CITROËN CARS CORPORATION

INDEX TO TRANSMISSIONS / DRIVESHAFTS

SERVICE BULLETIN #66

**DS 19 TRANSMISSION
SECOND GEAR AND REVERSE PATIOS**

1767-T modified

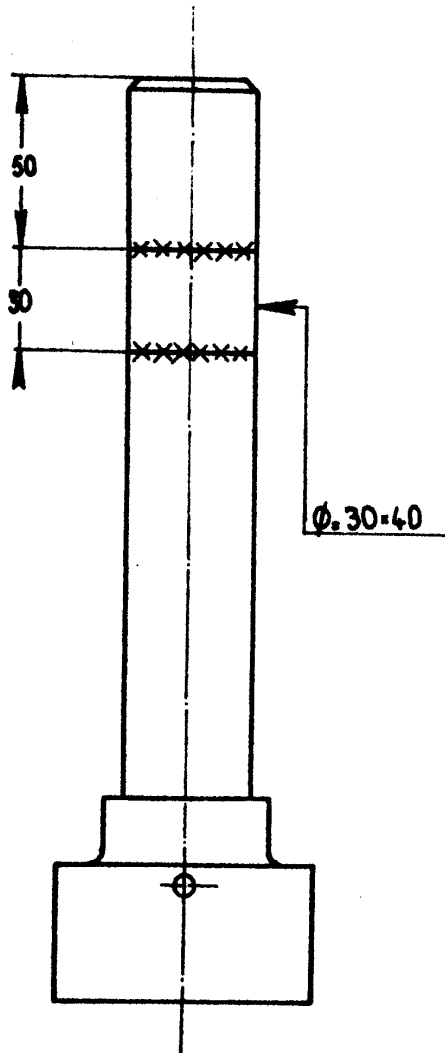
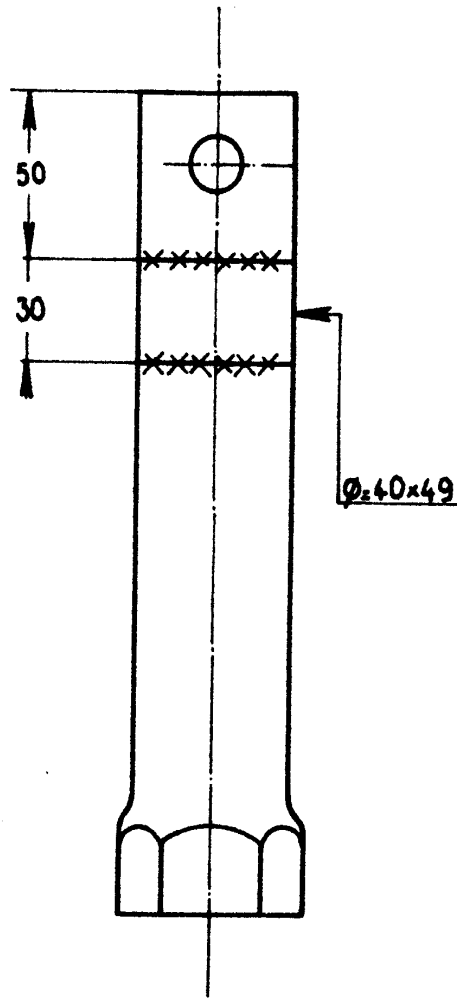
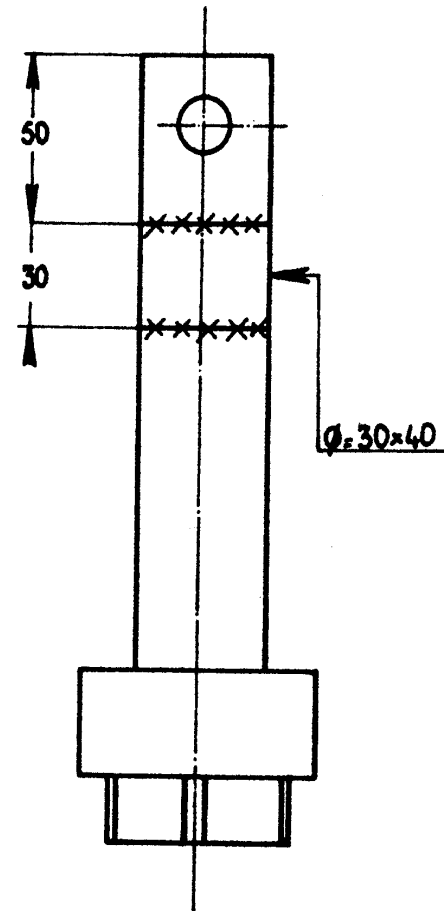
The tools 1767-T, 1770-T and 1771-T, suitable for the DS and SW previous to 1966 models as well as the ID previous to 1967 models, can be modified for use on the new models. It is sufficient to increase their length 30mm (1.18") as indicated in the drawings attached.

SUBJECT : Mechanical shift control

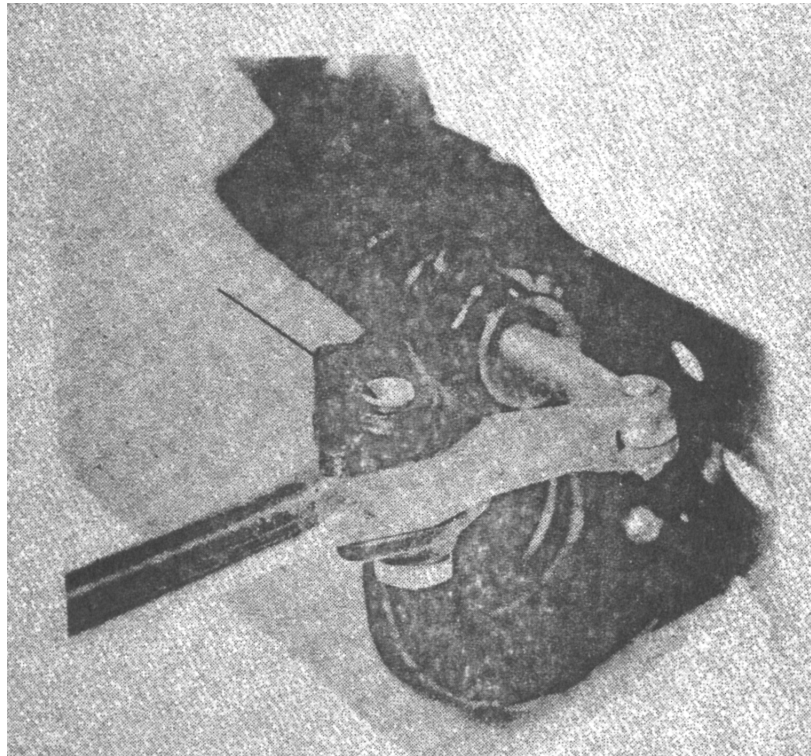
The shifting control shaft (DJ 334-4) of the above-mentioned models is modified. The shouldered pin of the shift lever at the dashboard is replaced by a threaded pin. The lower part of the stirrup straddling the shift lever is tapped to receive the threaded pin.

After setting in place, the end of the pin is expanded to prevent its rotation.

To remove the threaded pin, loosen it. The expanded collar at the end of the pin will break itself. When remounting the pin, tighten it just to the point where the stirrup binds the lever. Expand, or peen, the end of the pin, then loosen it slightly until the lever moves freely in the stirrup. It is possible to replace the old type shift control by a new type provided the shouldered pin is replaced by the threaded pin.

SUBJECT: GEAR BOX,

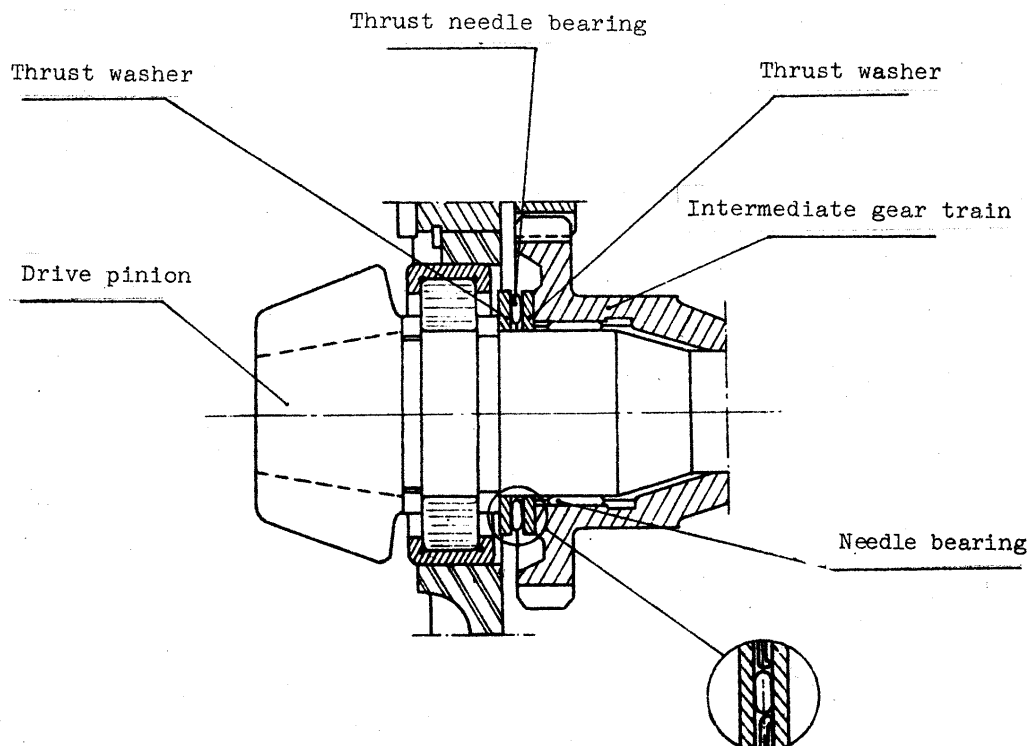
The thrust needle bearing 620229 is mounted BETWEEN TWO THRUST WASHERS (AM 333-330 to AM 333-225). These thrust washers should be chosen so as to obtain a lateral clearance of the intermediate gear train comprised between 0.10 and 0.20 mm (0.004" - 0.008").

On the drive pinion of the ring gear set AM344-01b, the diameter of the bearing surface of the thrust needle bearing and the bearing surface of the caged needle bearing of the intermediate gear are identical.

The bore of the caged needle bearings of the intermediate gears AM 333-5b or AK 333-5a is larger.

The front caged needle bearing of the intermediate gear 620202 (25x29x18.2) is replaced by a caged needle bearing 620319 (29.5x33.5x18.2)

SERVICE: The new parts can only be mounted as an assembly in the gear boxes of cars produced earlier. The instruction for reconditioning and adjustment of the new gear boxes are identical to those outlined in the Shop Repair Manual No.490, 1965 Edition.

Old Model

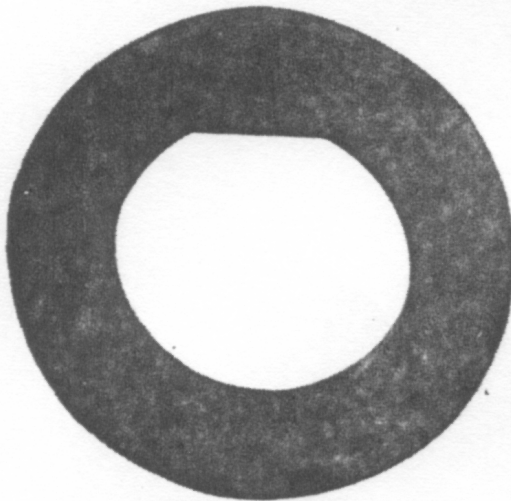
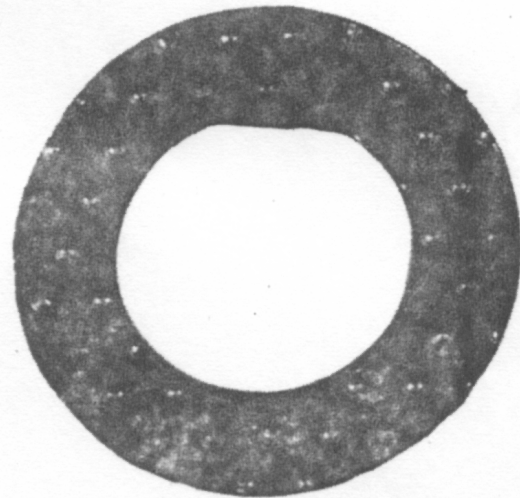
The stationery bronze thrust washer A 333-95, 4mm (0.158") thick at the front of the intermediate gear train, is replaced by a steel washer AZ 333-95b, 2.40mm(0.094") thick coated with an anti-friction alloy.

The intermediate gear train, A 333-5, is replaced by the gear train AZ 333-5 on which the posture of the surface facinh the thrust washer has been modified according to the thickness of the new washer AZ 333-95b.

SERVICE: The washer AZ 333-95b CAN BE MOUNTED ONLY with the intermediate gear train AZ 333-5.

IMPORTANT: The thrust washer surface having the spherical pitting must **IMPERATIVELY** be mounted facing the intermediate gear train.
